Subject/Title: Evaluation of Passive Sub-Slab Depressurization System  
Former TRW Microwave Site, 825 Stewart Drive, Sunnyvale, CA

**Re: Evaluation of Passive Sub-Slab Depressurization System, Former TRW Microwave Site, 825 Stewart Drive, Sunnyvale, California (CERCLIS ID#CAD00915988)**

Former TRW Microwave Facility  
Vapor Collection System - Roof Venting Compliance  
825 Stewart Dr, Sunnyvale, CA  
Project No: 60680270 Date: March 2022

**LOBBY ROOF VENTS LOOKING NORTH**

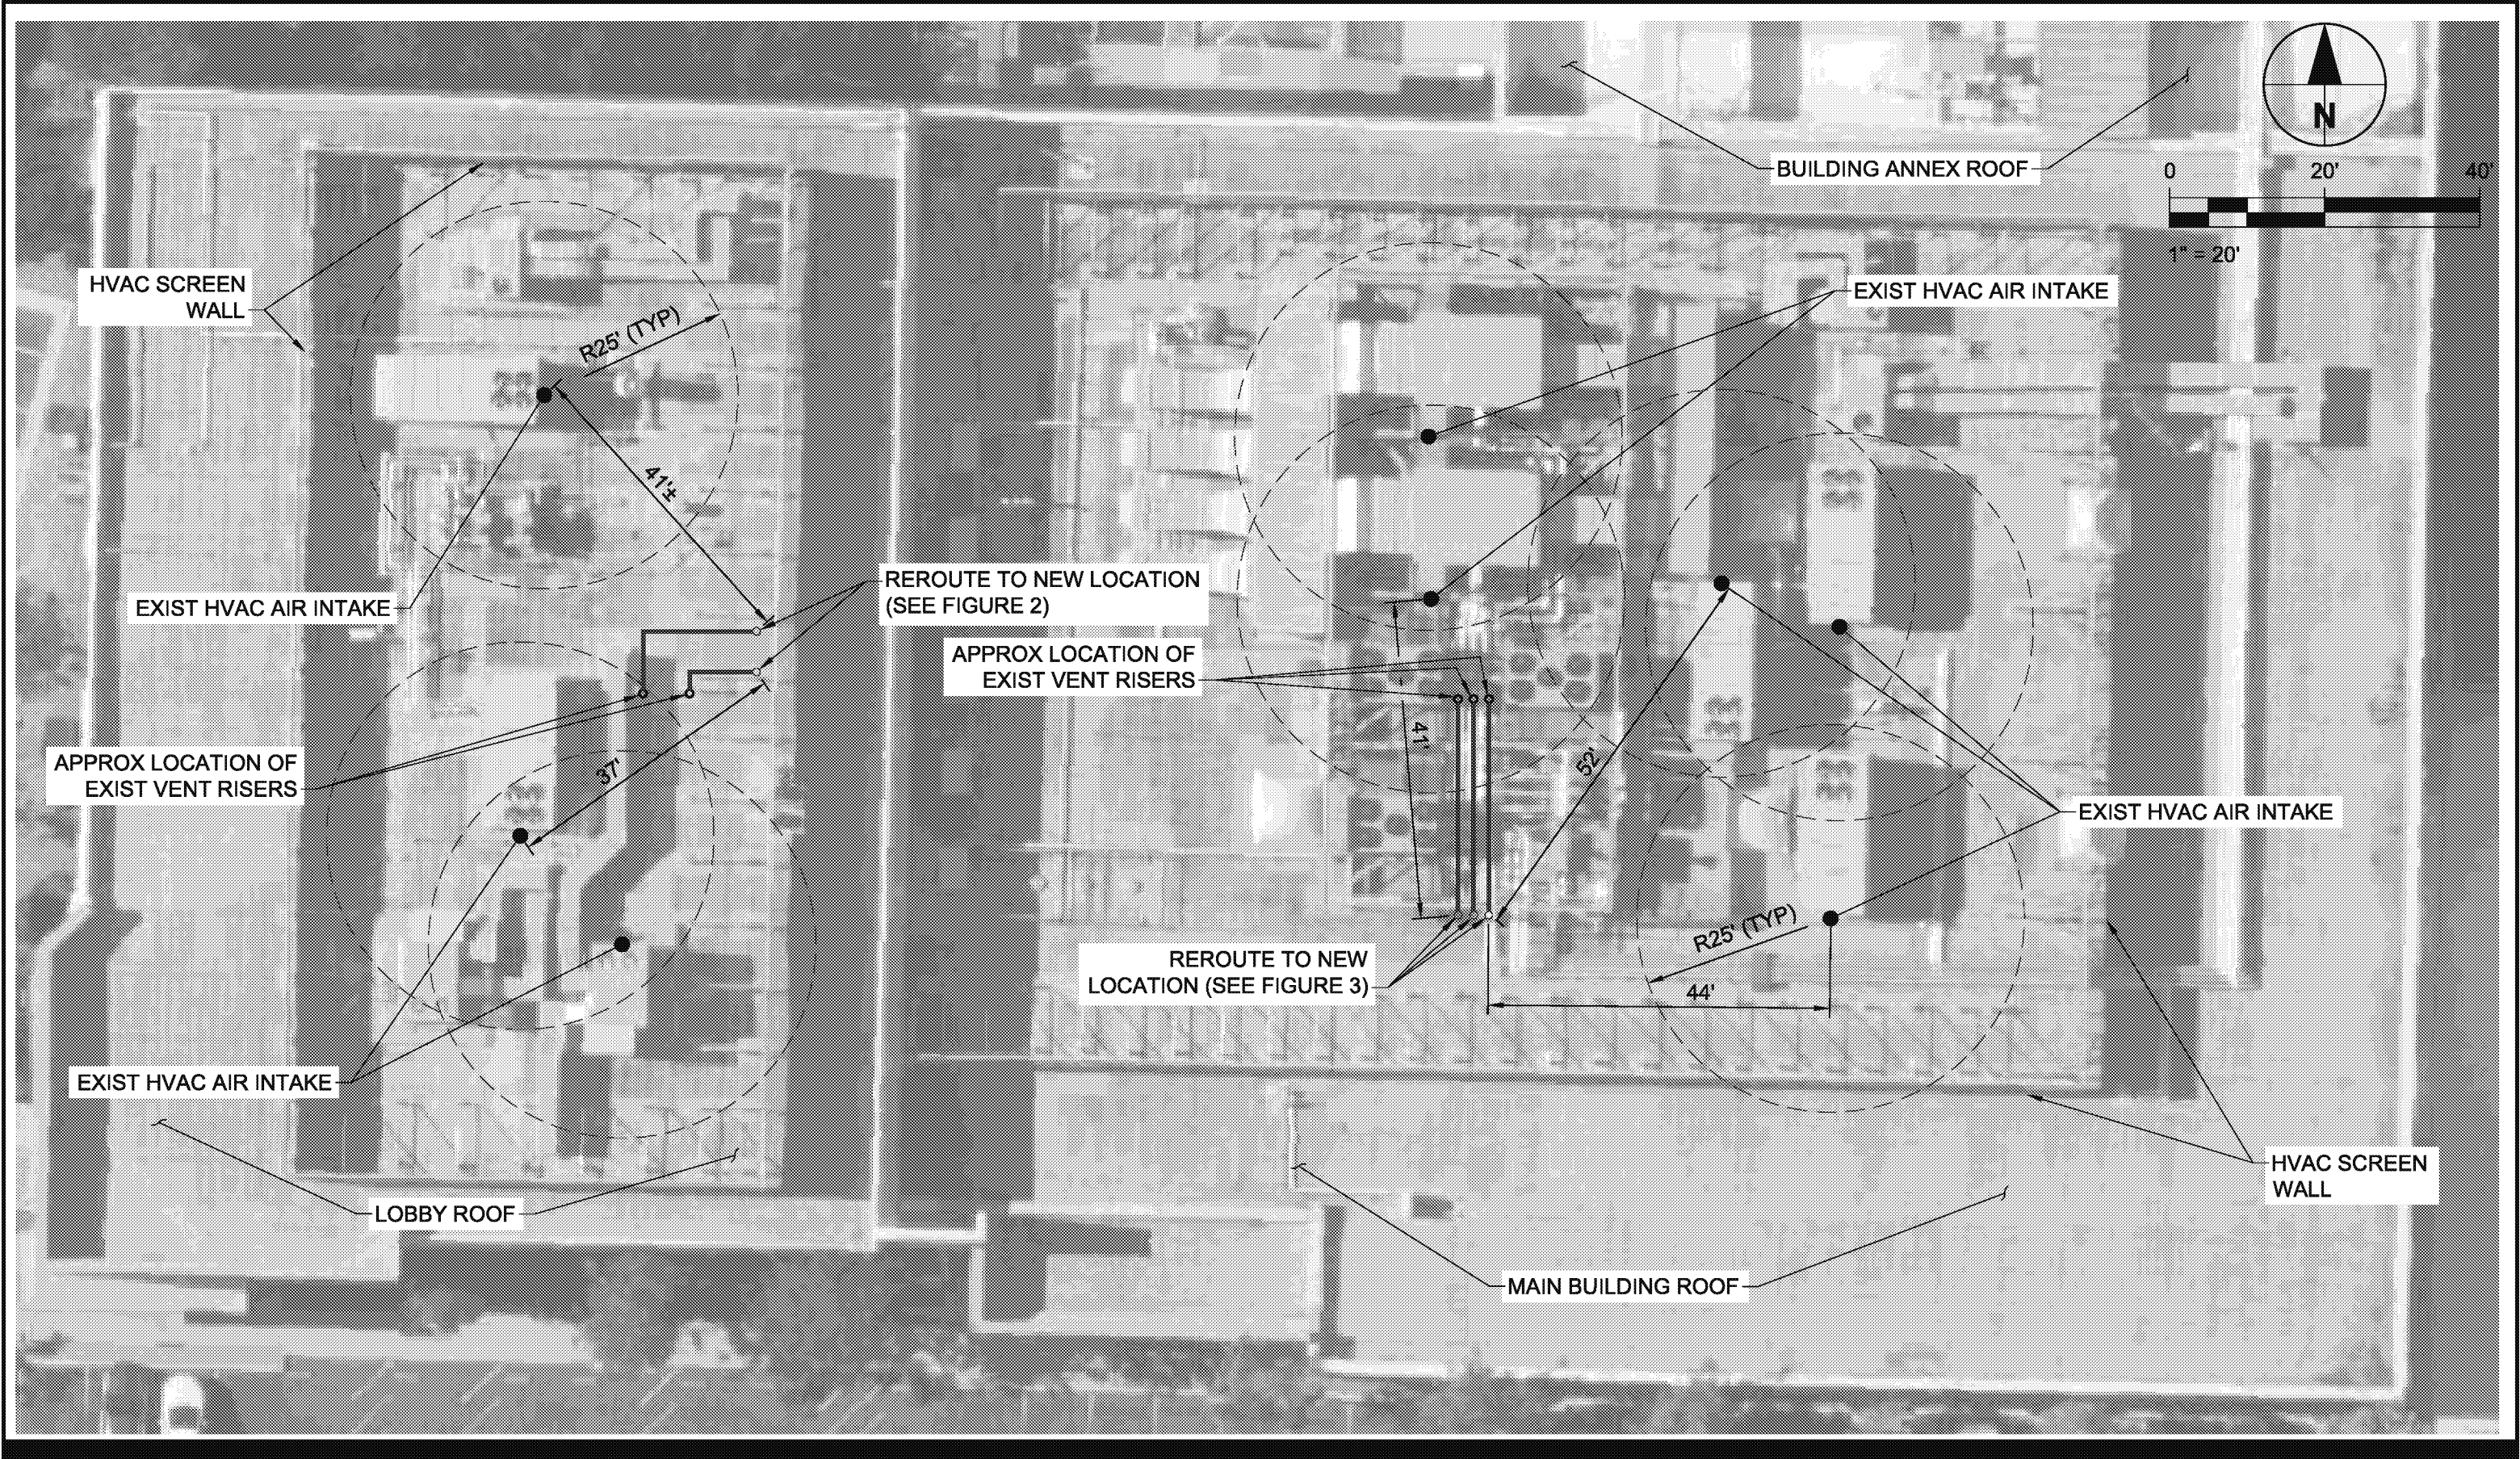
1. REMOVE EXISTING VENT TURBINE, CUT PVC RISER AND INSTALL 90° BEND.
2. INSTALL NEW 4" SCHEDULE 40 PVC RISER AND ATTACH SALVAGED VENT TURBINE.
3. INSTALL PIPE SUPPORT AT 5' MAX SPACING (DURABLOK SERIES DB-20 ROOFTOP SUPPORT SYSTEM OR EQUAL).
4. MOUNT NEW 4" SCH 40 PVC PIPE TO EXIST SCREEN WALL HORIZONTAL BRACING.

**AECOM**  
Figure: 1

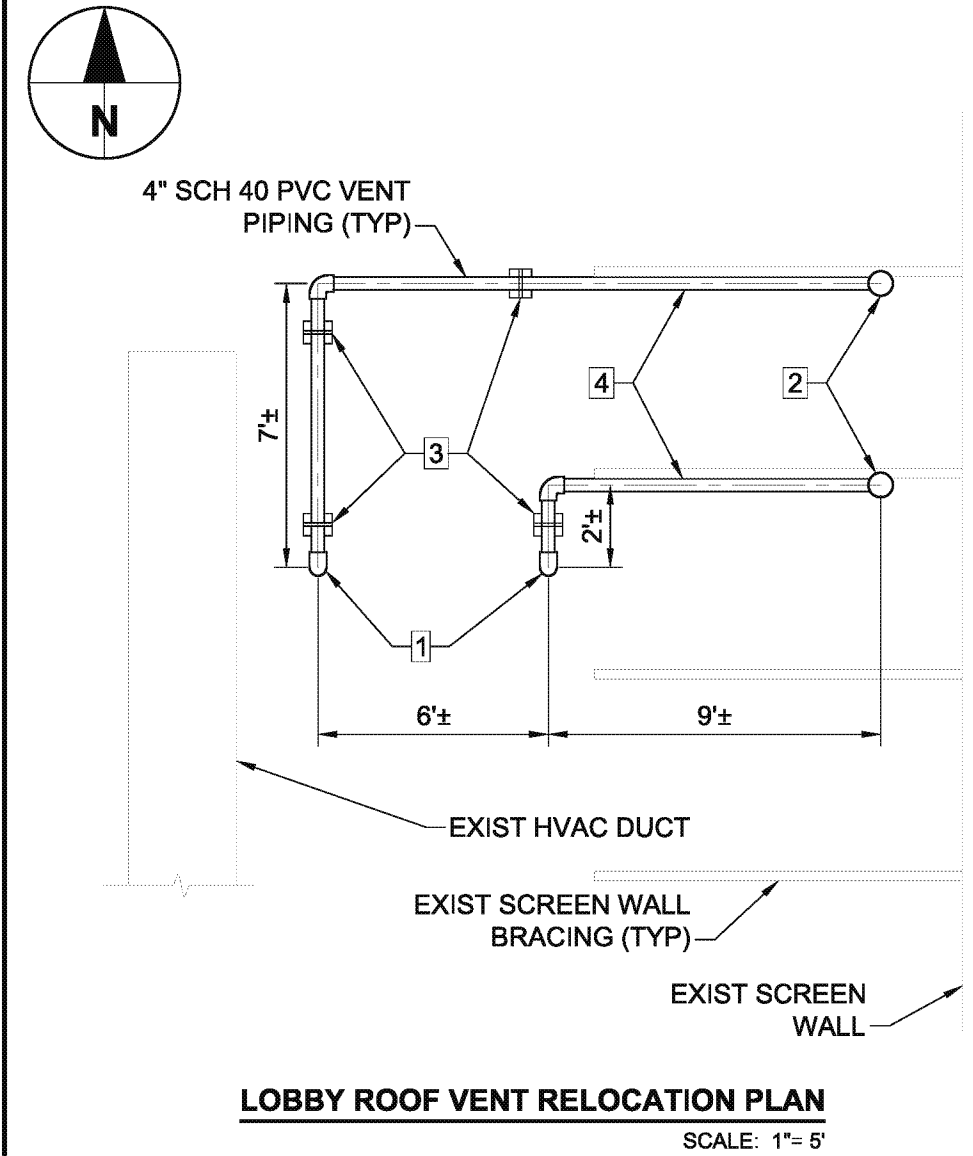
**Figure 1** shows an aerial view of the three vents on the Main Building Roof and the two vents on the West Building roof and their proposed relocation outside the 25-foot spheres drawn around each intake.

The Main Building vent risers are proposed to be relocated approximately 27 feet to the south of the existing vents and approximately 42 feet from the nearest HVAC intake (**Figure 1**). The West Lobby Building vent risers are proposed to be relocated approximately 15 feet to the northeast, placing them approximately 37 feet away from the nearest HVAC intake (**Figure 2**). The height of the risers is designed to allow for airflow across the turbines while maintaining the overall building profile with all equipment located below the top of the windscreen at the edge of the building. The proposed piping schematic is shown on **Figure 3**. The scope of work will involve removing the existing turbines, trimming the vent to height, placing a 90-degree elbow, and routing the pipe horizontally to the new vent riser location as shown on **Figure 3**. The piping will be supported on the roof using Dura-blocks consistent with the existing supports for piping and conduit. The risers will be secured to existing structures as shown on **Figure 2** and **Figure 3**.
